ADDENDUM NO. 3

**Freedom Park Restroom/ Snack Bar Renovation Project
Spec No.FWRR.09.26.27**

July 29, 2026

1. **Added specifications for the cooling shutters**
(Attached – Exhibit A pages 5-11)
2. **Construction plan clarification markup summary (Attached -Exhibit B –**
pages 12-20)
3. **Construction plan RFI callout (Attached - Exhibit C – pages 21-32)**

Exhibit C-1 RFI - Callout

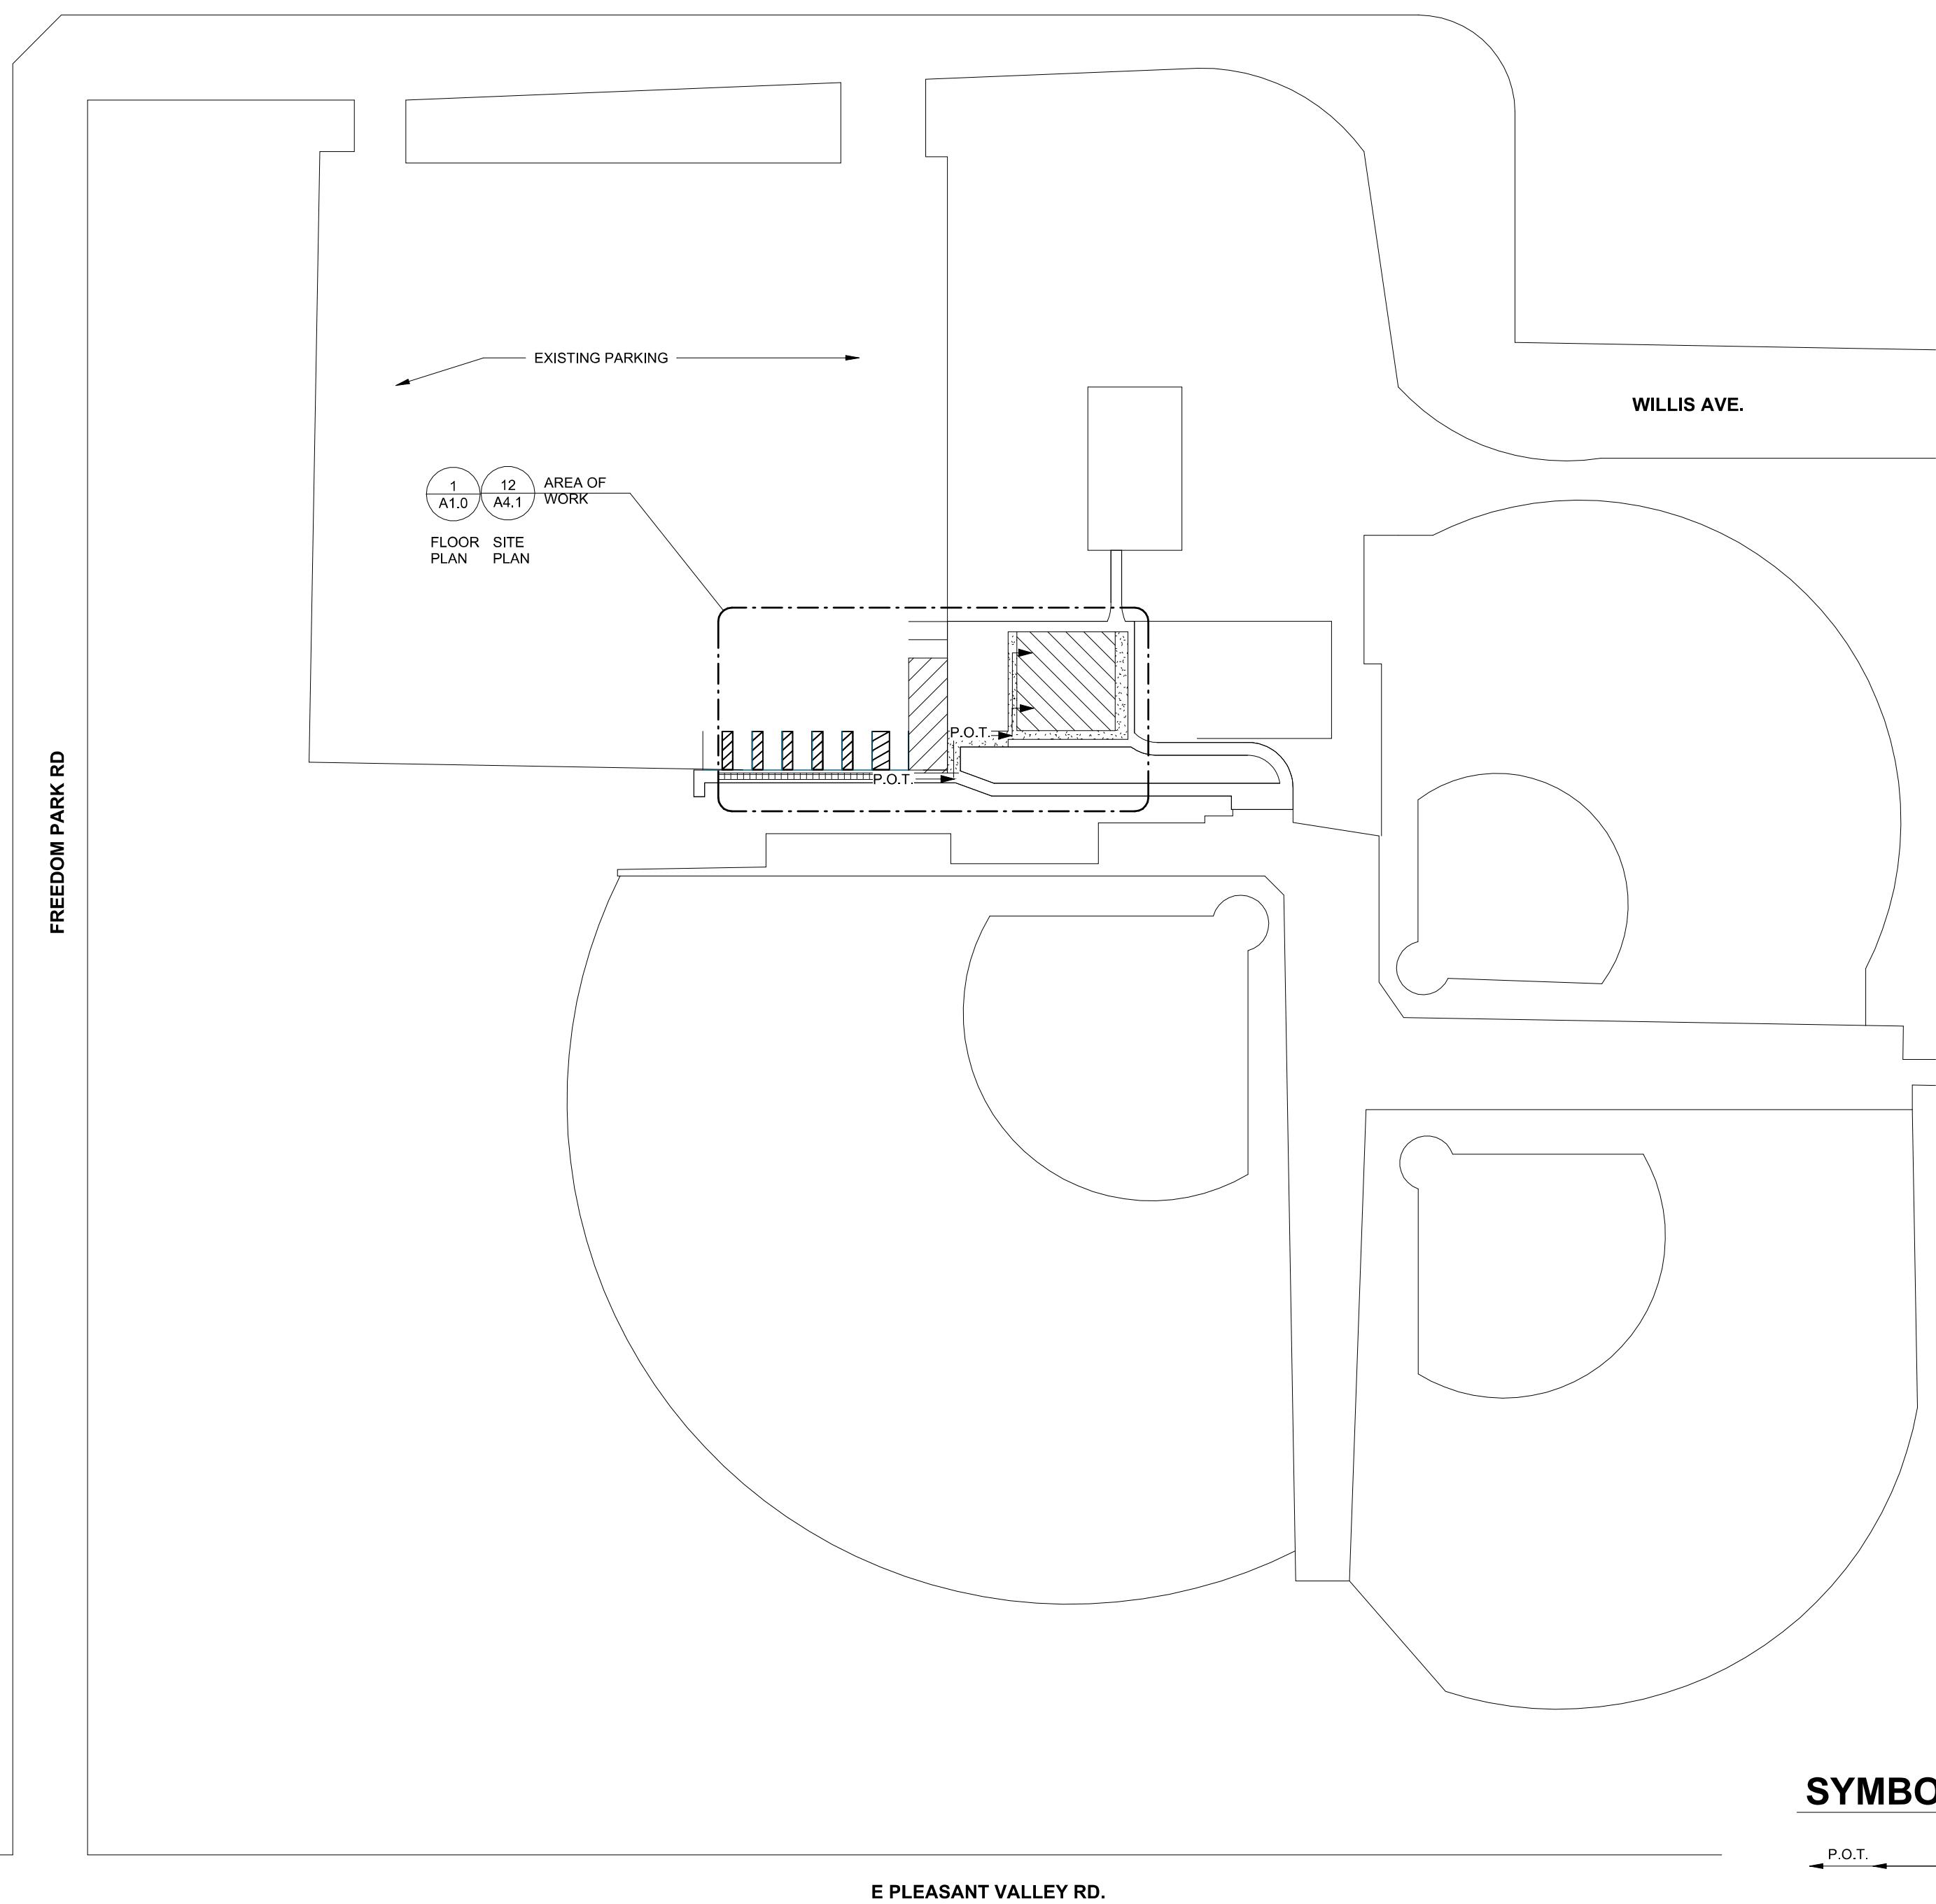
All existing plumbing piping is exposed in MTC Room and appears to be in bad shape, is the intent to replace all exposed piping with new or re-use and modify as needed for new plumbing fixtures?
Ref Demo Note # 3

All existing plumbing piping is exposed in MTC Room and appears to be in bad shape, is the intent to replace all exposed piping with new or re-use and modify as needed for new plumbing fixtures?
